Investigation of the Webster Passive Treatment System

Technical Report Provided by Hedin Environmental through the Trout Unlimited AMD Technical Assistance Program December 2013

Figure 2. Cross section of system showing key elevations. Horizontal is not to scale.

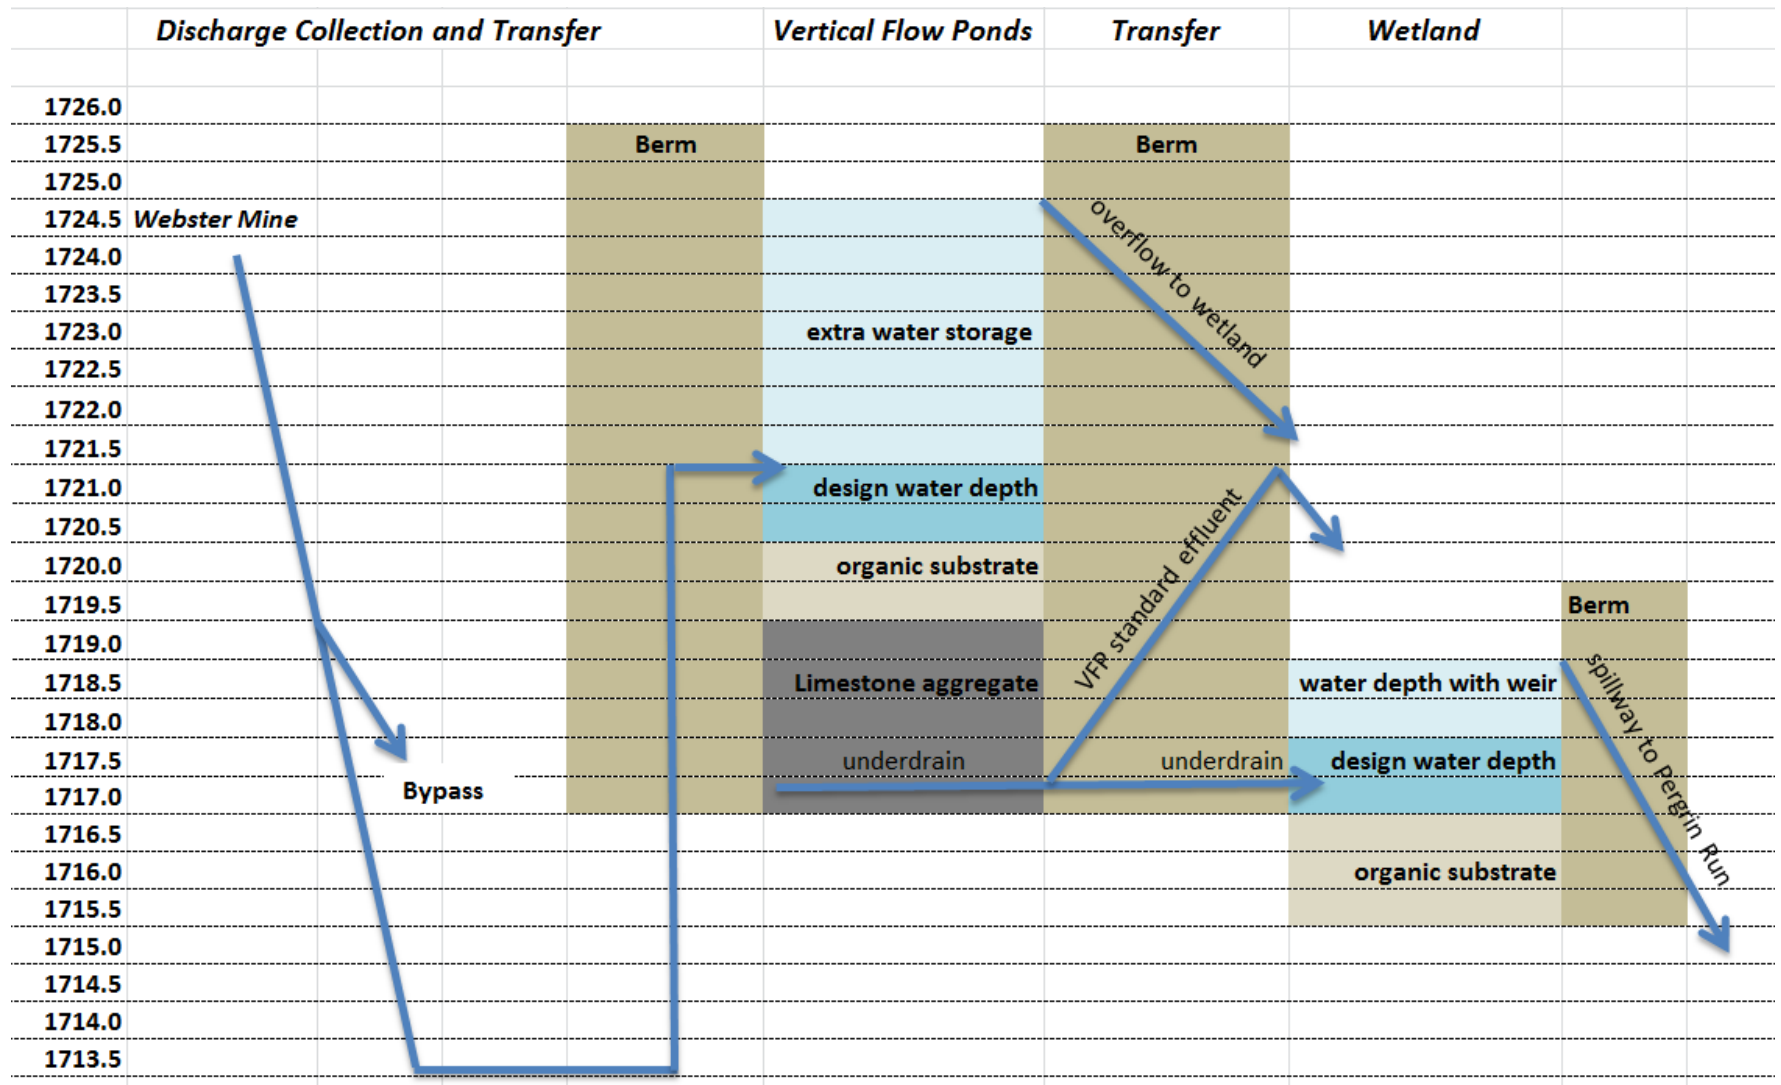
The VFPs cannot be passively drained empty because they discharge to the wetland which has a water elevation higher than the bottom of the VFPs. The current water elevation in the wetland is about 1719 ft which is only 0.5 ft below the top of the limestone aggregate (see Figures 2 and 8 for elevations). The inability to completely drain the VFPs makes investigation of the condition of the limestone aggregate or the underdrain pipes very difficult because most of the excavation will be underwater. The VFPs can, in theory, be pumped empty but this would involve at least a week of 24-hour pumping, assuming that the underdrain is not plugged. In fact, both underdrains are partially plugged at this time. Assuming the 130 gpm flow rate that VFP2 was discharging in October 2013, it would take 12 days of round-the-clock pumping to drain VFP2 empty.

- The bottom of the VFPs should be higher than the wetland water elevation so that they can be drained empty. This can be accomplished by either lowering the wetland or raising the bottom of the VFPs.

Figure 7a. Webster System underdrain design. The thin lines within the two VFPs are 6 inch perforated pipes that discharge collected water to the wetland.

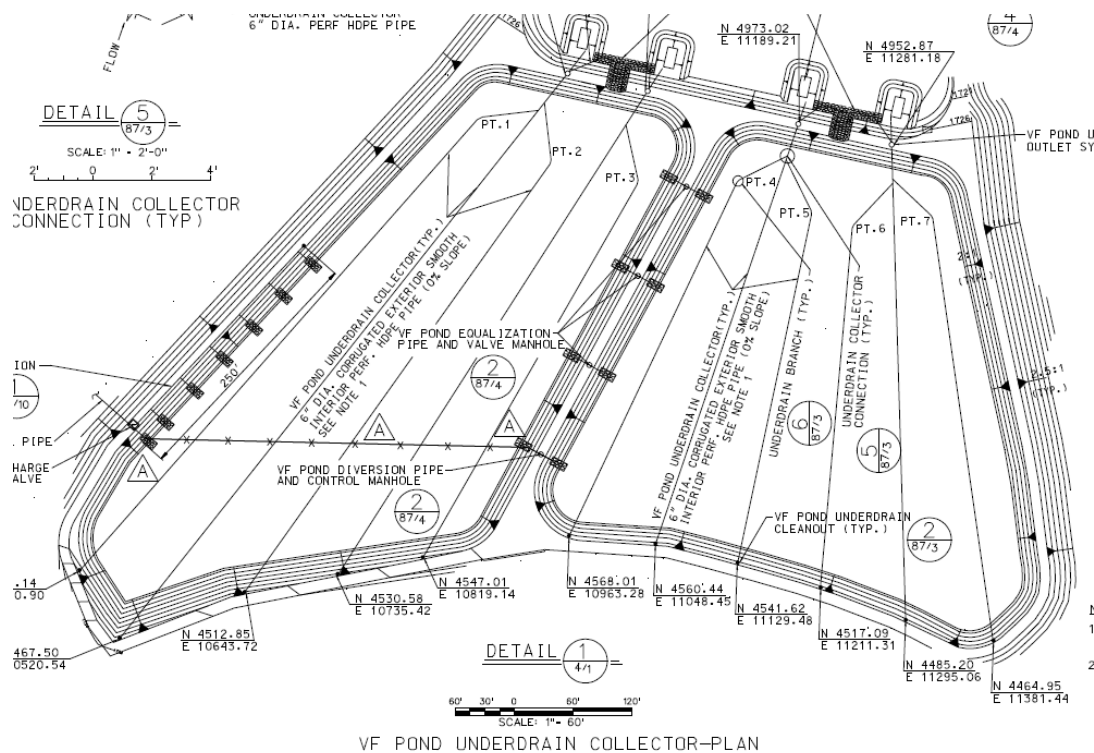
The Webster underdrain system is unusually designed in several respects. First, the Webster underdrain contains less pipe than other effective VFPS. Figure 7a shows the layout of Webster underdrains. The underdrains consist of 5-6 runs of perforated 6 inch diameter HDPE pipe that are separated by 50-60 ft. Figure 7b shows the layout of the HD underdrain. It consists of 6 runs of perforated 4 inch diameter HDPE pipe that are separated by 15 ft. Table 6 shows the total length of underdrain pipe in each system. The HD system contains more underdrain pipe despite being half the size. The Webster system contains 61 ft² of water surface for each foot of pipe, while the ratio for the HD system is 21. A system with too little underdrain pipe is likely to provide inefficient hydraulics and have areas of limestone aggregate that provide little treatment benefit. In addition, concentrating the flow potentially concentrates the deposition of metal solids precipitated at part of the treatment process. This accumulation of solids produces head loss and ultimately plugging.

- The underdrain system contains several unique characteristics that could have contributed to the systems failure.
 1. The underdrain piping system is small. The Webster VFPs contain about one-third the pipe density of the Hunters Drift system. This could result in less efficient distribution of AMD in the substrates.

- The system should contain a flow distribution system that allows direct control of flow to each VFP and the bypassing of high flows to the wetland. This change could be accomplished with pipe installed on the existing central berm and the new berm identified below.
- New underdrain plumbing must be installed. The current underdrain is inadequate and must be replaced with a header-lateral setup.
- The manholes that obstruct movement of equipment on site should be removed.
- The valves should be replaced with water level control structures which involve much less O&M.

Figure 8. Detail of the Webster system underdrain. The pipes are bedded in 3 inches of AASHTO 57 noncalcareous gravel.

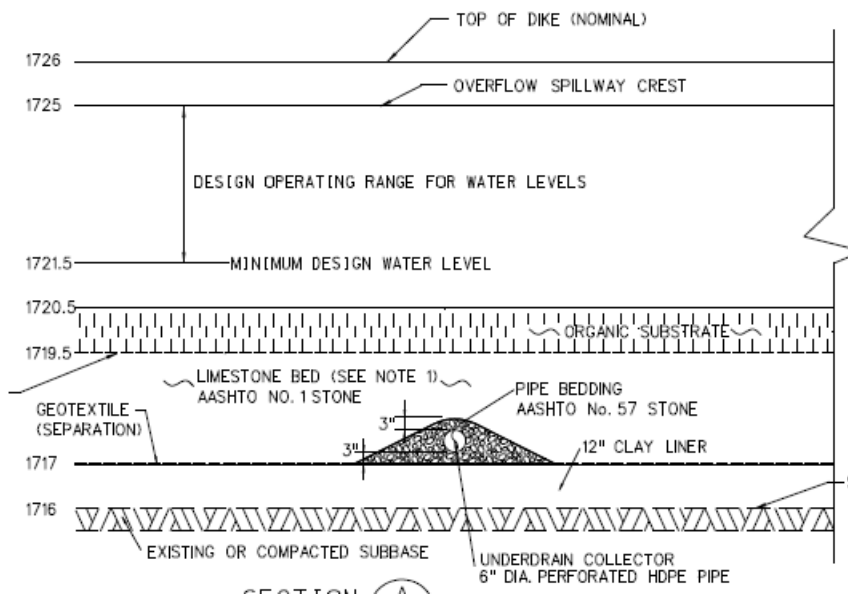
A second unusual aspect of the Webster underdrain system is that the pipes are completely enveloped with AASHTO 57 non-calcareous aggregate (Figure 8). It is uncommon for the perforated underdrain pipes in VFPS to be completely enveloped with small gravel. In most VFPS, the perforated underdrain pipes are placed directly within the limestone aggregate. The consequences of surrounding the underdrain pipes with gravel are unknown. If solids are forming in the underdrain, they would likely be trapped in the gravel surrounding the pipes, which would eventually plug the underdrain system.

3. The underdrain pipes are buried with small gravel. If solids are forming in the limestone aggregate, the gravel around the pipes would likely become plugged long before the limestone aggregate plugged. The cleanout pipes

are enveloped in gravel. This porous substrate could provide a substantial flow path for untreated AMD to flow directly into the underdrain.
